STAFF RECOMMENDATION

NCPC File No. 7179/7075

FORT BELVOIR – NORTH POST NEW ADMINISTRATION BUILDING FOR THE OFFICE OF THE CHIEF OF ARMY RESERVE

November 23, 2010

Project Location to Historic Resources

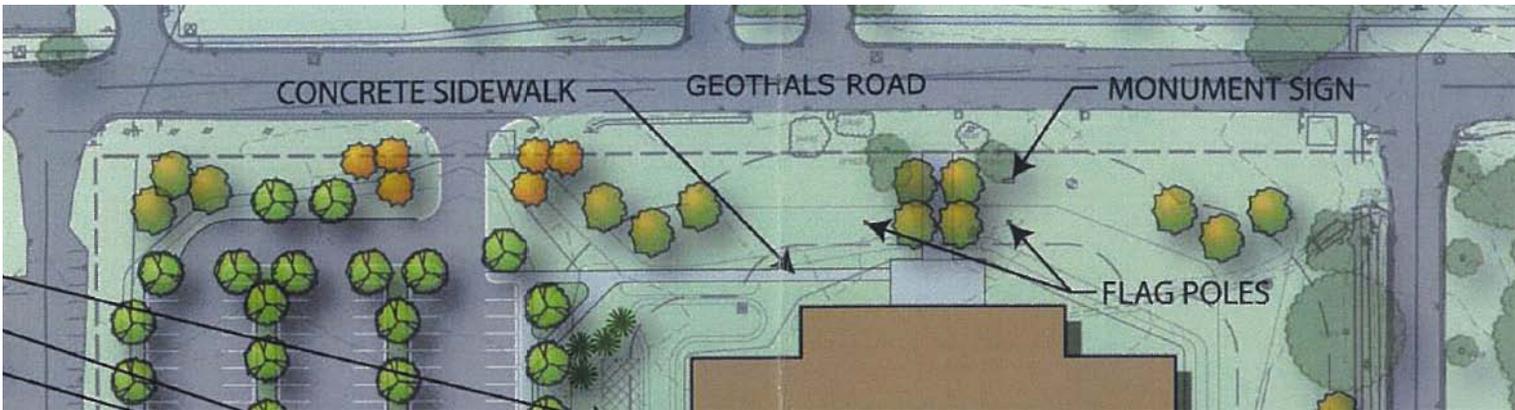
Due to the potential views of the project from the Woodlawn Quaker Meetinghouse and the Woodlawn Historic District, staff encourages the Army to evaluate the existing tree coverage for potential gaps that may be filled to lessen views to the building; this includes the project site and adjacent areas. Staff notes that the Army proposes to add landscaping on the eastern and southeastern side of the project; however, additional landscaping may be needed on adjacent areas to screen the building. Staff encourages the Army to evaluate gaps along Route 1 for landscaping opportunities.

Black Road Current Condition

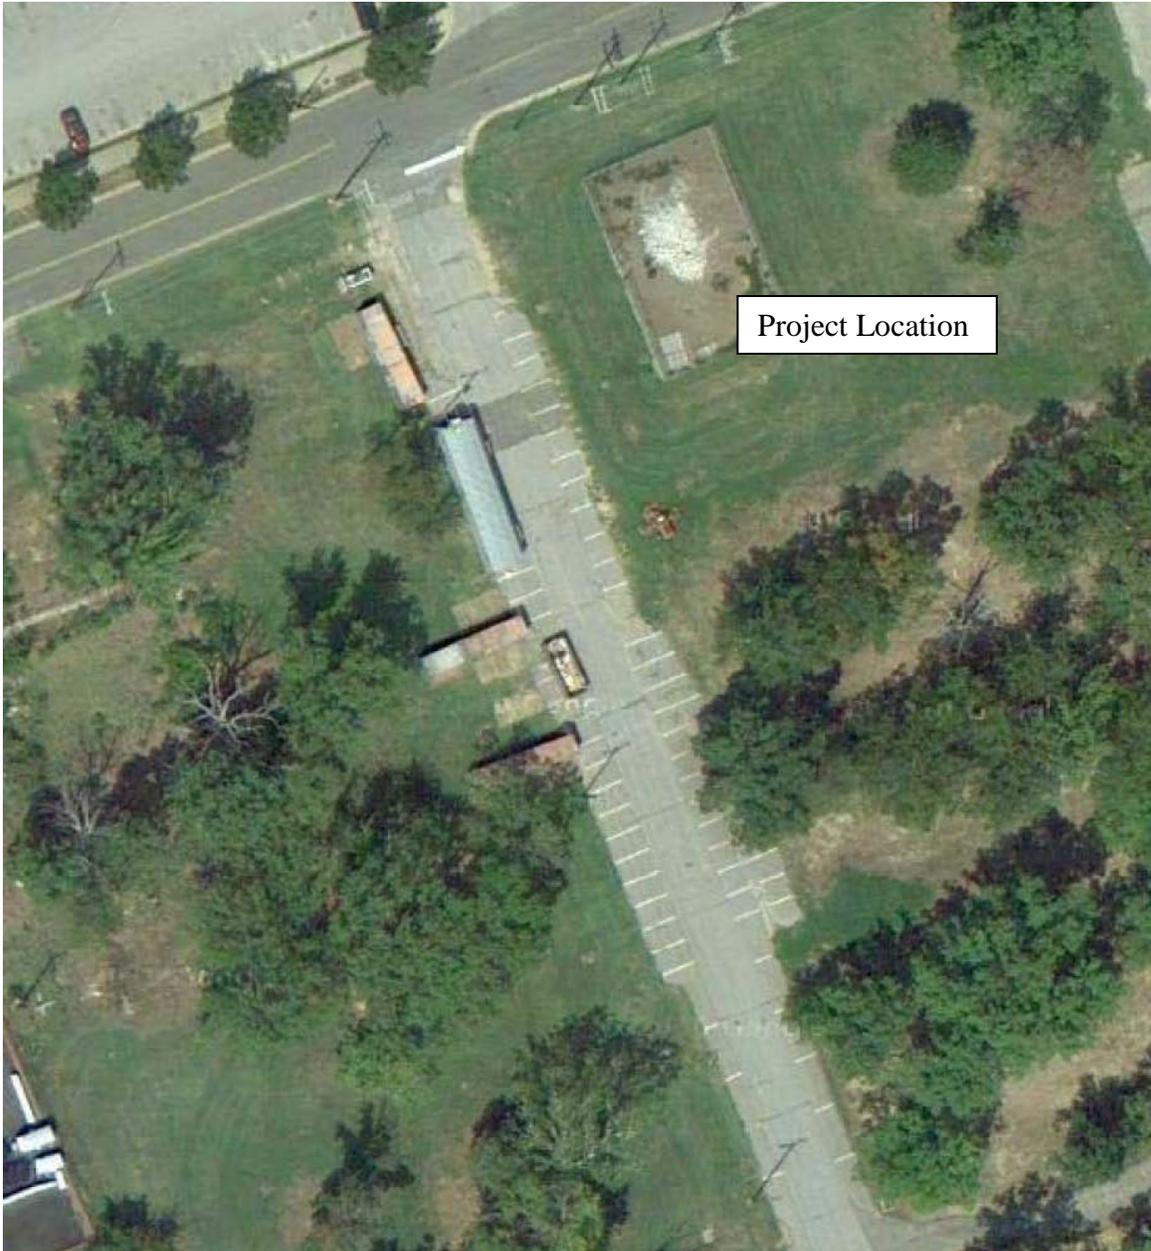
Staff also recommends that the Army evaluate the opportunity to improve the condition of Black Road. While staff recommends all of Black Road be improved, the project should address the area adjacent to the project site. Currently, Black Road has a cartway with no defined dimensions or edges. The road provides striped parallel and perpendicular parking; however, due to no defined edge, parking spaces are not adequate in length causing people to park on landscaped areas. Staff recommends the Army evaluate the construction of a curb for Black Road and the reduction of Black Road parking spaces to minimize impervious surfaces.
